RCA-14-22-002-1: Improperly Routed Wheel Speed Sensor Harness

Document Type	Customer Satisfaction Campaign Bulletin
Date	June 8, 2022
Affected Region(s)	USA
Affected Model(s)	R1T
Model Year(s)	2022
Approximate Build Dates	August 2021 - November 2021
 Refer to the FSA Dashboard to determine if this document applies to a specific vehicle.	
Vehicle System	14 - Brakes
Minimum Service Location	Mobile

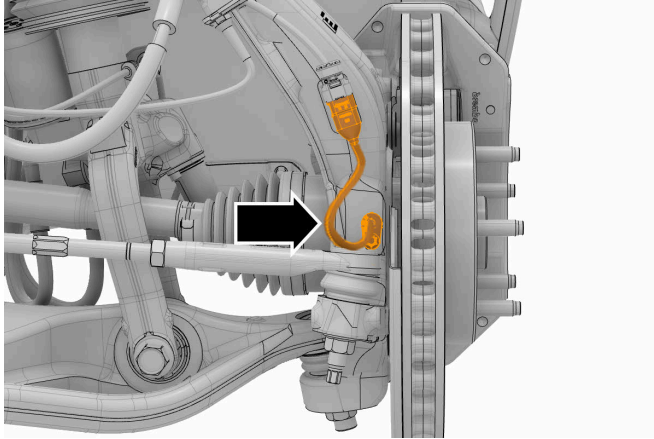
1. Raise and Support Vehicle (refer to service manual procedure 981020017).
2. LH front: Inspect the wheel speed sensor for damage. Make sure the wheel speed sensor harness is routed inward, as shown.

Note: Shown with components removed for clarity.

- If the wheel speed sensor is undamaged and the harness is routed inward, continue to the next step.
 - If the wheel speed sensor is damaged: Replace: Sensor, Wheel Speed, Front, LH (refer to service manual procedure 147010010).
 - If the wheel speed sensor harness is routed outward, perform the [Reroute Harness](#) procedure, then continue to step 3.
3. Repeat step 2 on the RH side.
 4. Reinstall all components that were removed for access and replace all non-reusable components.

Reroute Harness

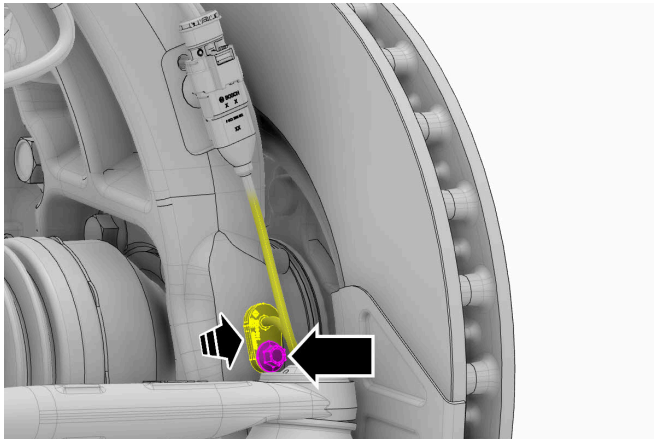
Note: Shown with components removed for clarity.

2. Install the component as described in the Installation section of Service Manual procedure 147010010.

Step Number	Torque (Nm)
1	8
